Official Transcript of Proceedings
NUCLEAR REGULATORY COMMISSION

Title: Advisory Committee on Reactor Safeguards
 ABWR Subcommittee Meeting

Date: Friday, August 23, 2019

ABWR DC RENEWAL

Containment Overpressure Protection System (COPS)

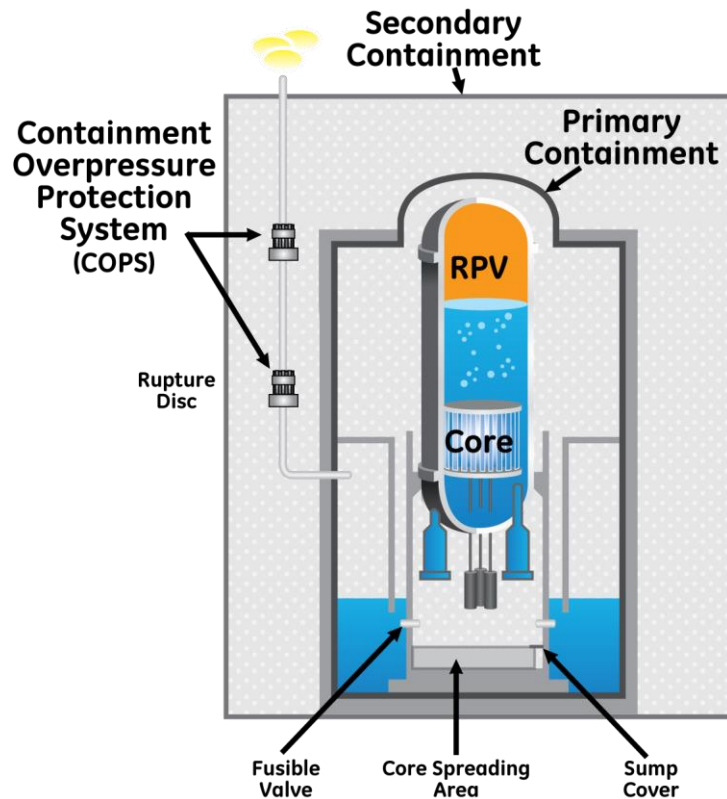
11 GEH proposed to increase to COPS, the
12 containment overpressure protection system, pipe
13 diameter and rupture discs to correct an error in the
14 flow rate calculation. So this is your classic
15 tightened modification, as we defined earlier.

Revised (increased) the diameter of the vent lines and rupture disc

- During detailed design the flow resistance in the laid out piping was higher than originally assumed
 - Longer pipe runs with more fittings
